# UNITED STATES PATENT AND TRADEMARK OFFICE

APPLICATION NO.	FILING DATE	FIRST NAMED INVENTOR	ATTORNEY DOCKET NO.	CONFIRMATION NO.
10/788,926	02/25/2004	Jalal Ashjaee	NT-216C1-US	1956

**Office Action Summary**

### **DETAILED ACTION**

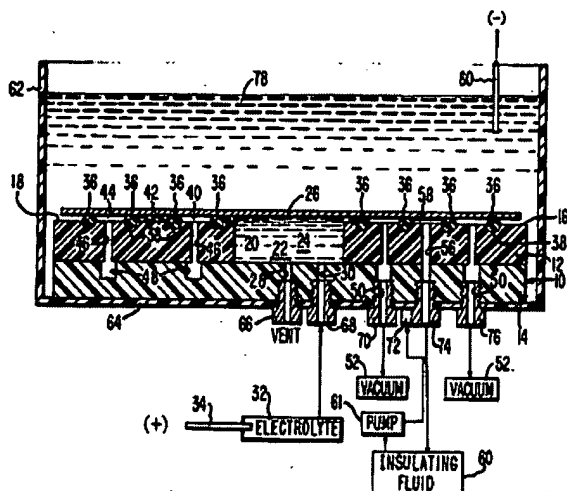
8. Claims 1, 12, 39, 44, 49, and 52-54 are rejected under 35 U.S.C. 102(b) as being anticipated by Gibbs' 4,043,894.

With reference to Figure 2, col. 2, line 56 to col. 3, line 26, Gibbs discloses an electrochemical processing apparatus for a semiconductor comprising an inner seal member (second O ring 36 from the center), and an outer seal member (4<sup>th</sup> O ring 36 from the center).

so perform. In this instant, even though wafer 36 submerges in processing solution during processing; however, the O-rings 36 is capable assisting in preventing the solution from reaching the backside inner region of wafer 36.

In col. 4, lines 25-50, Gibbs discloses that the O rings keeps the wafer backside from being anodized while the front side of wafer is being anodized.

Regarding to the limitations of "removable seal" in claims 39 and 52 in col. 4, lines 48-50, Gibbs discloses that the O-rings 36 can be periodically replaced to insure that a good seal to the wafer is maintained. In view of the ordinary meaning of the word "removable", that is "that can be removed", the examiner believes that Gibbs's O-rings being replaceable read on the "removable" limitations.

Regarding to the limitations of 'contacts' in claim 52, Gibbs discloses electrode 80 and a plurality of fluid contacts to supply power to the front side of substrate 26.

Fig. 2D

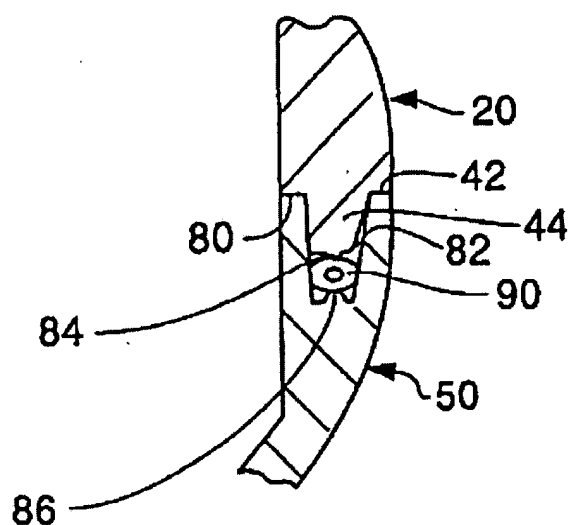
Gibbs has been discussed above, but does not disclose a hollow O ring for sealing purpose.

With reference to Figure 2D, col. 5, lines 43-67, Fratello discloses that a hollow O-ring 90 would advantageously provide a fully compressed seal to achieve a fluid tight seal.

Thus, it would have been obvious to one having ordinary skill in the art at the time the invention was made to have substituted the solid O ring of Gibbs with a hollow O ring as

taught by Fratello in order to advantageously provide a fully compressed seal to achieve a fluid tight seal.
